STAFF CORRECTIONS TO ATTACHMENT B

Downtown Livability Height and Form Recommendations

Attachment B

Podium (Base)

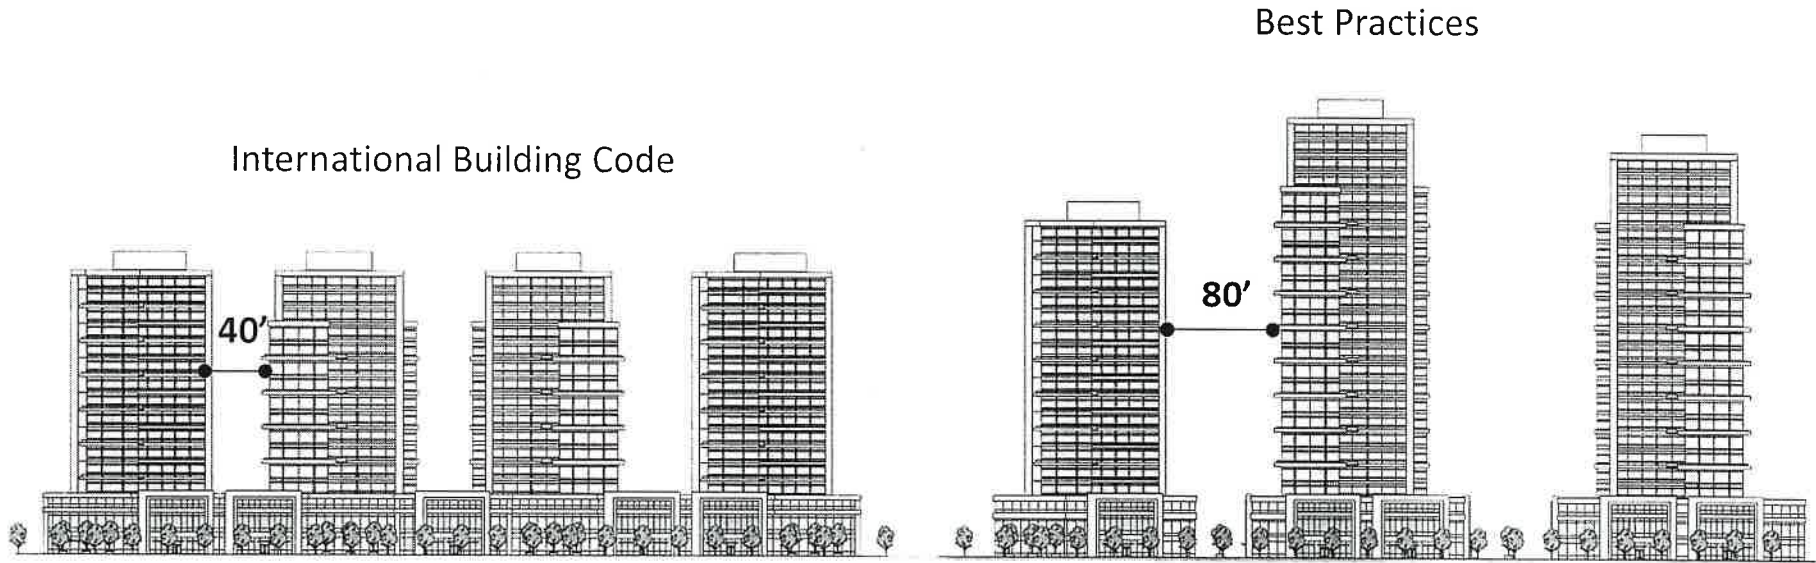
- Podium height is not currently defined except first floor above 40 ft reduces in size (floor plate limits). Result can be an overly tall podium that does not relate to the pedestrian environment and streetscape.
- Staff recommends defining a maximum podium height measured at the roof of 45 ft.
- Departures allowed.

Downtown-Wide: Tower Spacing

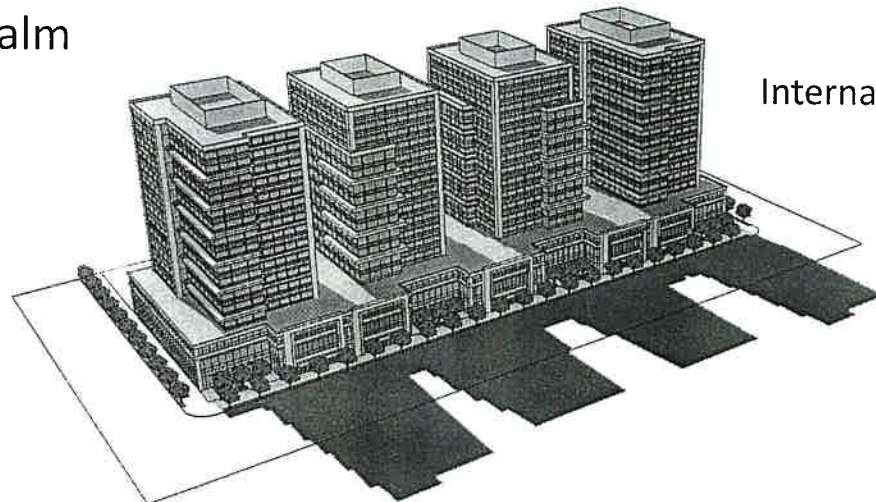
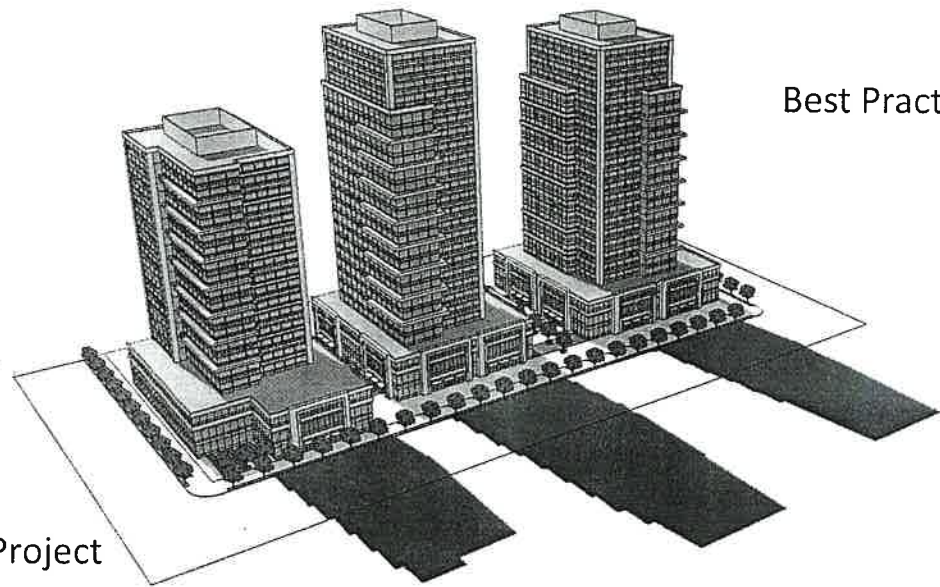
- Increased Tower Separation from 40 ft to 80 ft applicable to buildings over 70 ft in height

Downtown-Wide: Tower Spacing

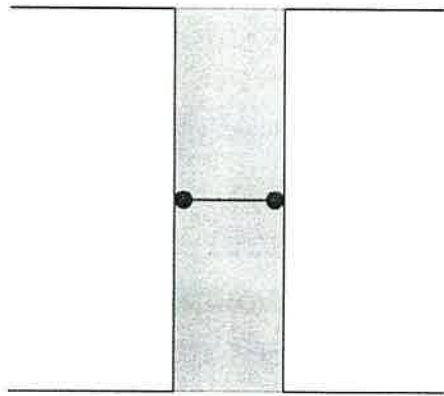
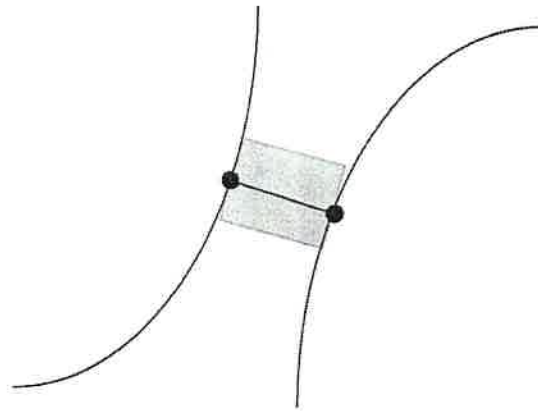
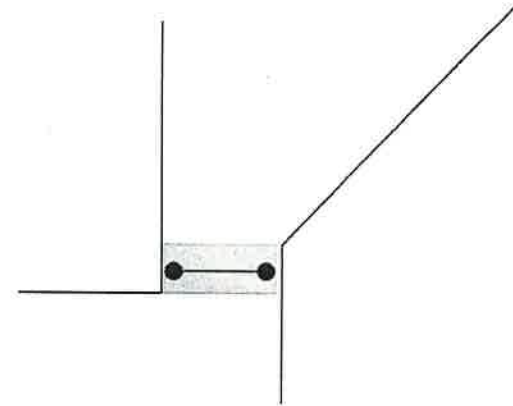
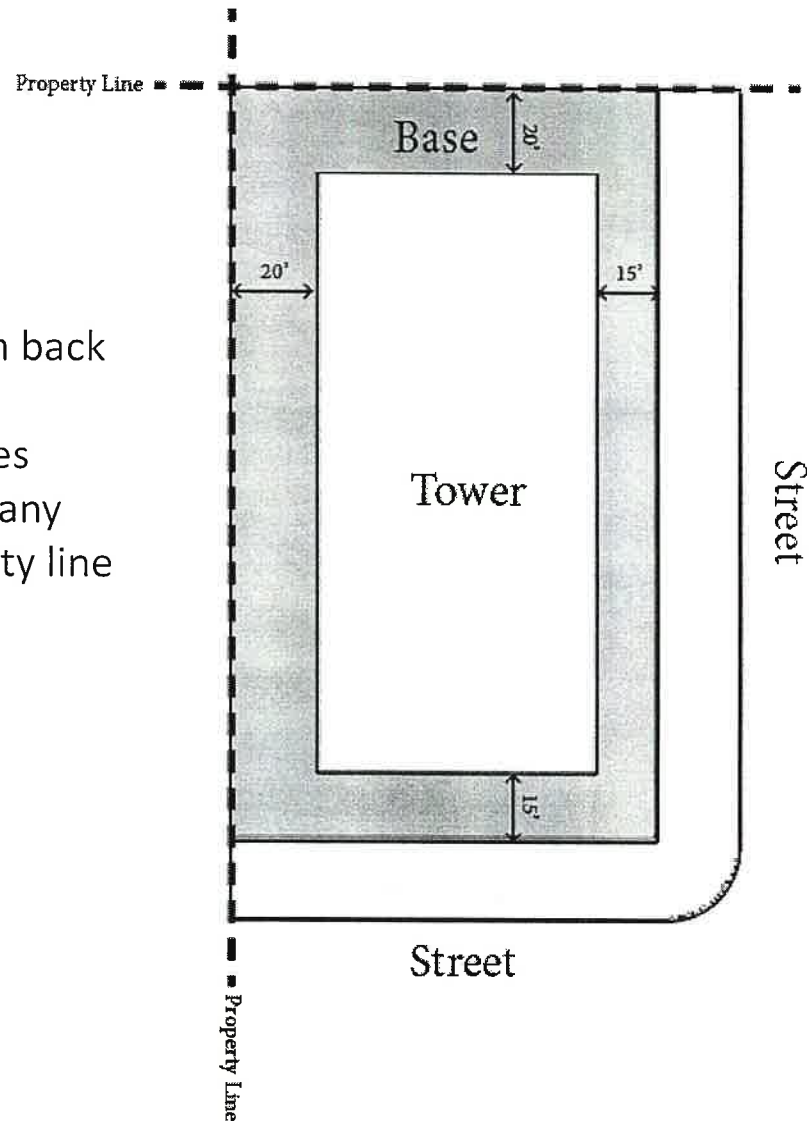
- Departures allowed for Fluid/Slender/Unique Forms

Downtown-Wide: Floor Plate Reduction

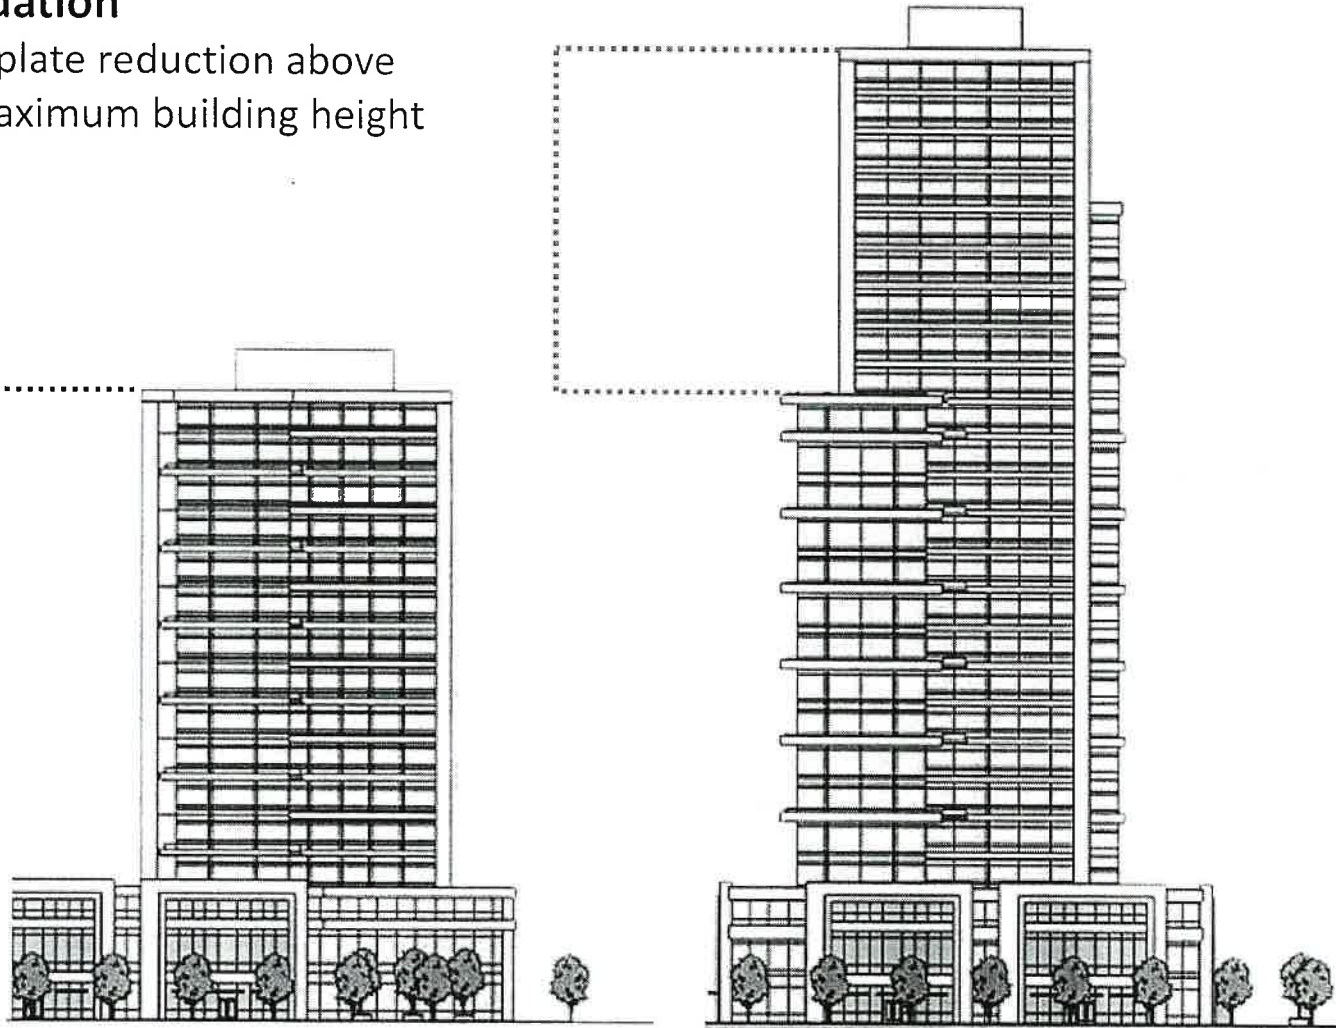
- 20% floor plate reduction above existing maximum building height

Downtown-Wide: Connected Floor Plates

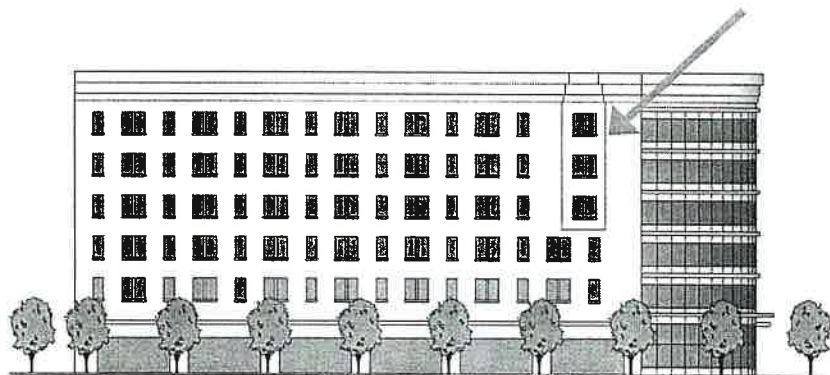
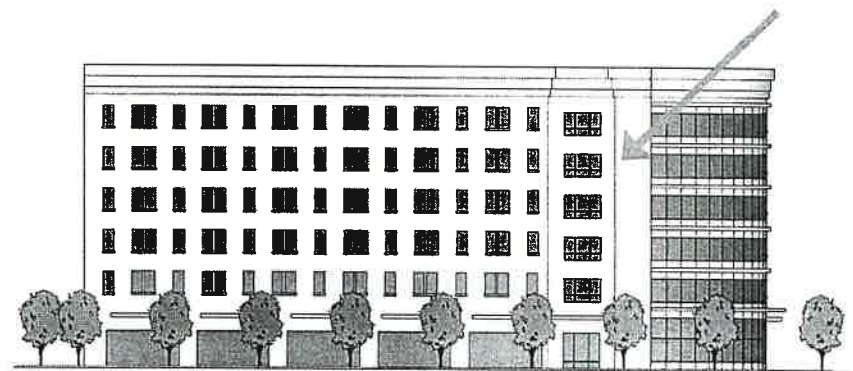
- “Connection” between 3’-0” and 7’-0” in depth and a minimum 7.5% of façade length
- “Connection” extends from grade to roofline of building
- Enhance distinct and separate elements through transition of building materials
- Floor area of units or office space not permitted
 - Habitable space not permitted
 - Space only allowed for exiting
- Portals and entries to be allowed as part of the “connection”

Downtown-Wide: Connected Floor Plates

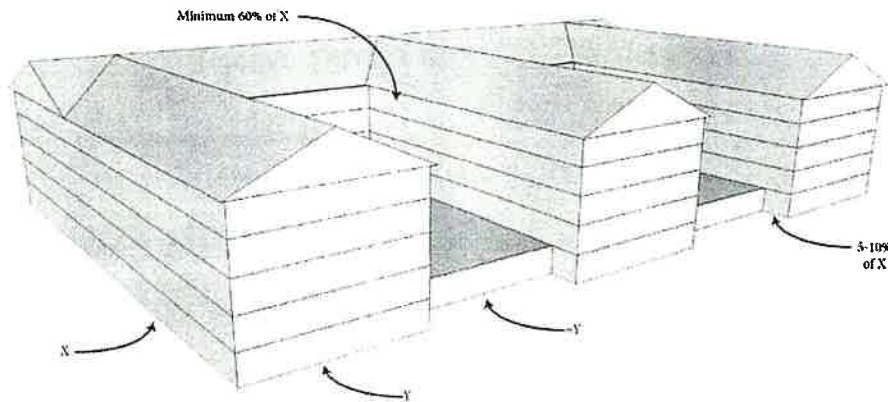
- Separation that establishes an aesthetic of distinctly separate buildings
- Enhance modulation
 - Entrances
 - Stoops
 - Recesses
 - Protrusions

Downtown-Wide: Wind/Shade/Shadow

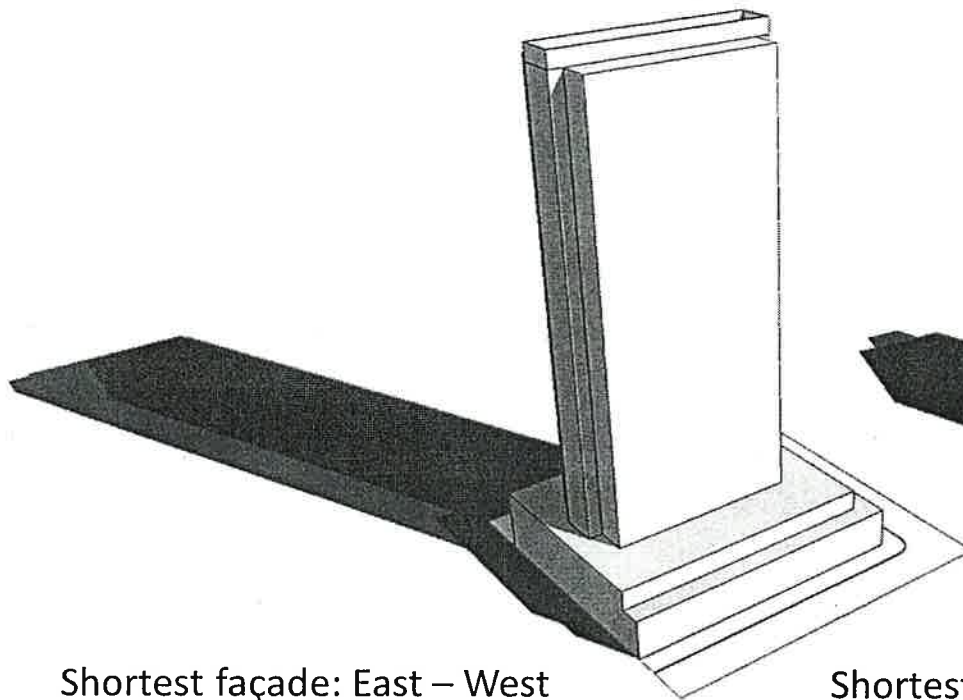
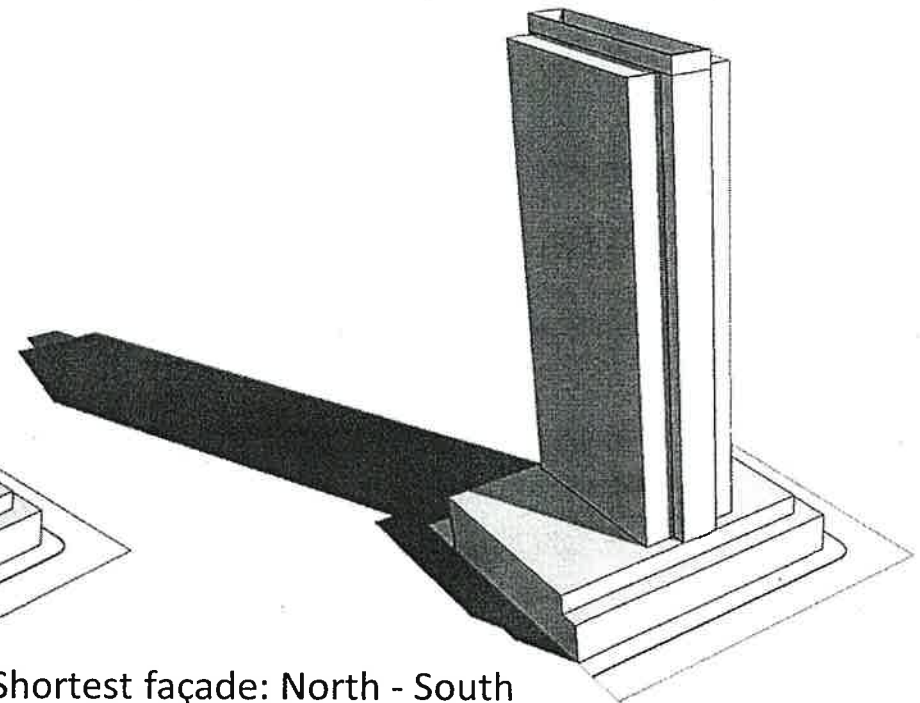
- Orient buildings with the shortest façades oriented north and south
- Require any public space earning FAR Amenity Incentive System points to conduct shade/shadow study
 - Impact during peak usage
 - 11 am – 2 pm

Downtown-Wide: Wind/Shade/Shadow

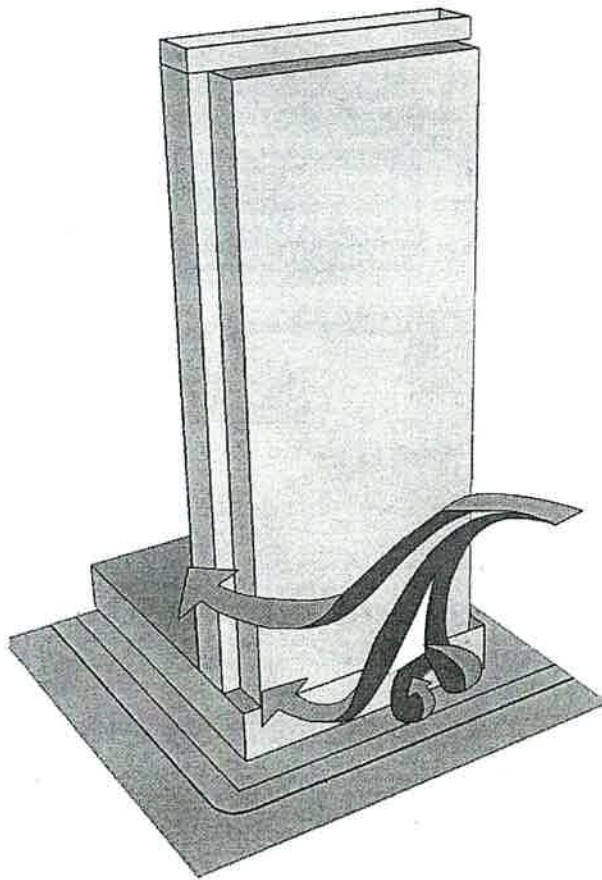
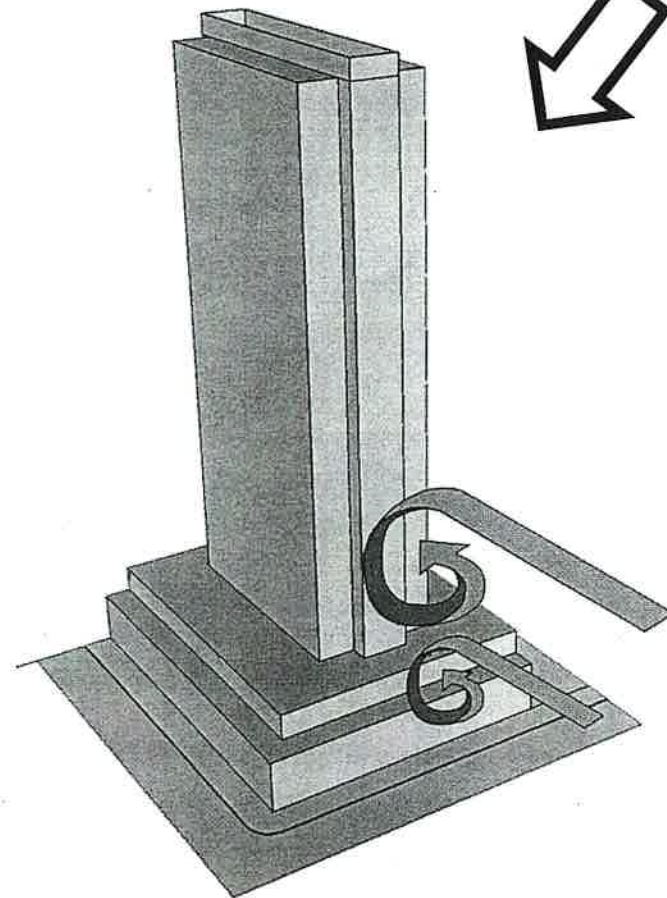
- Orient buildings with the shortest façades oriented north and south
- Provide stepbacks on all facades oriented towards public space

Downtown-Wide: Tripartite (Base, Middle, Top)

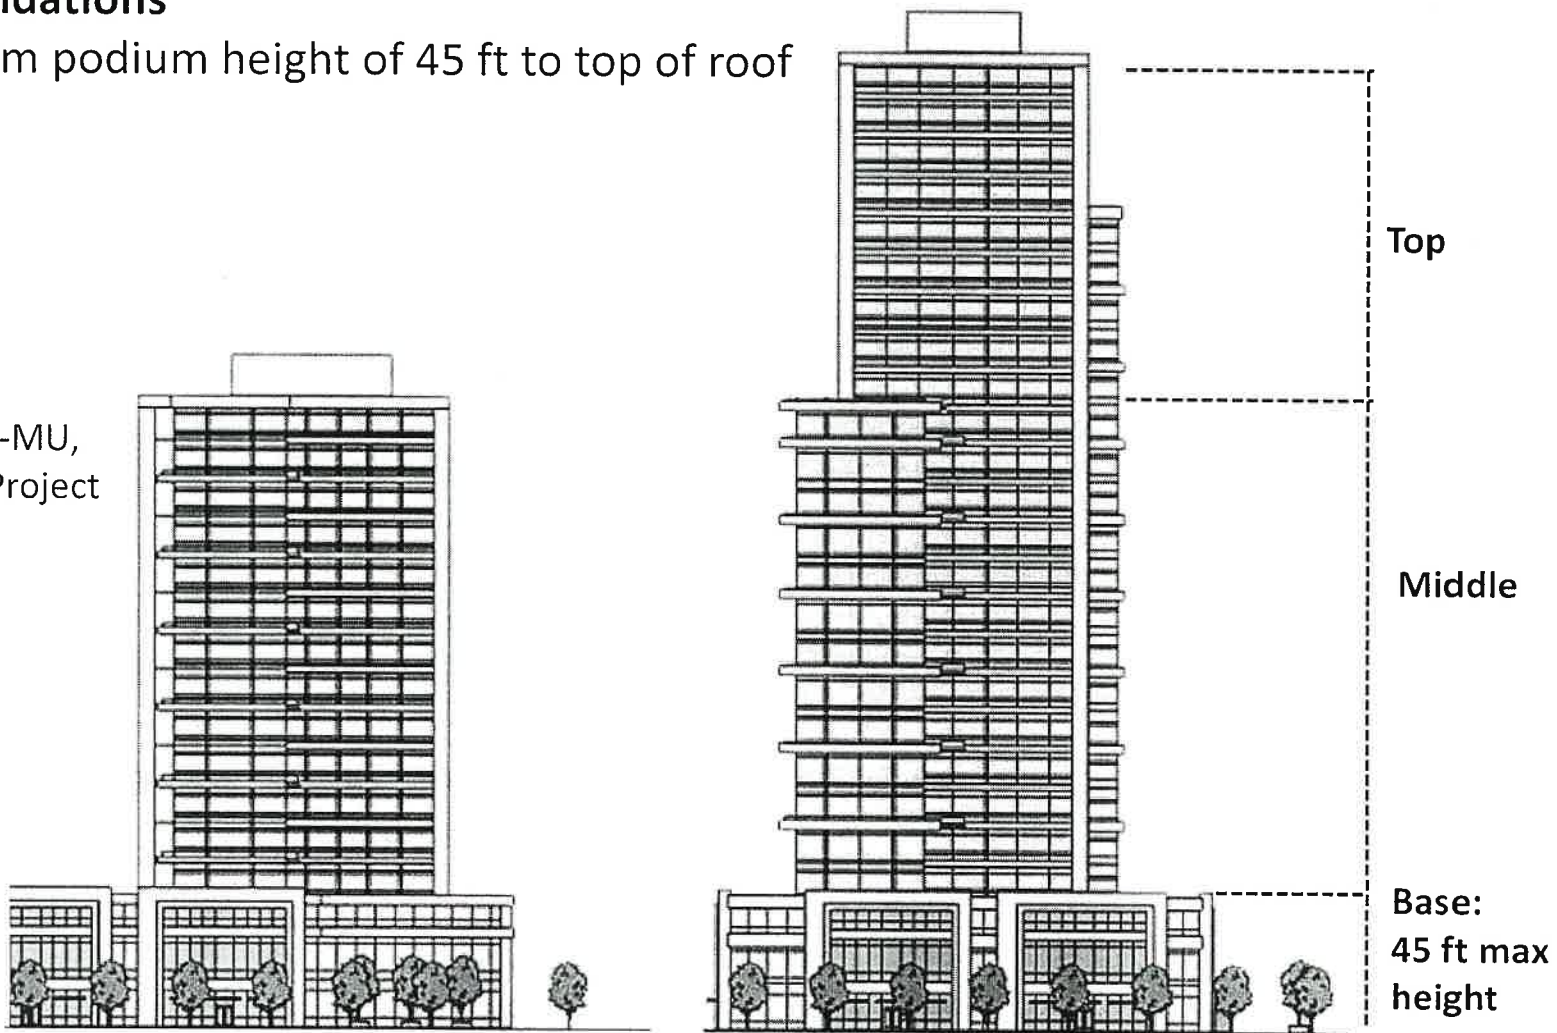
- Maximum podium height of 45 ft to top of roof

Downtown Mixed-Use (DT-MU), Nonresidential

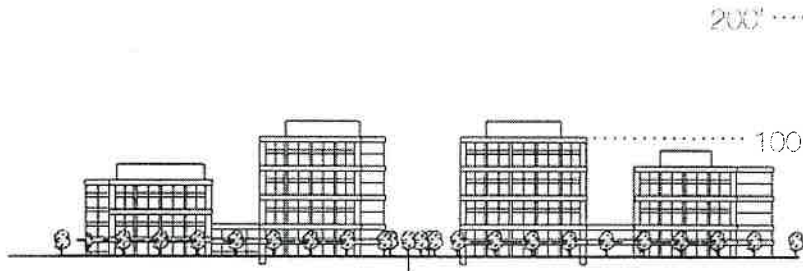
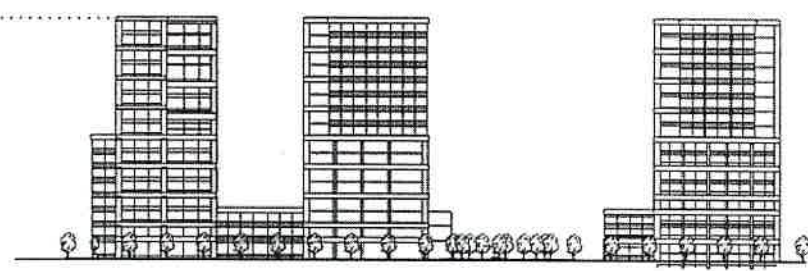
- 5.0 FAR
- 200 ft height limit*
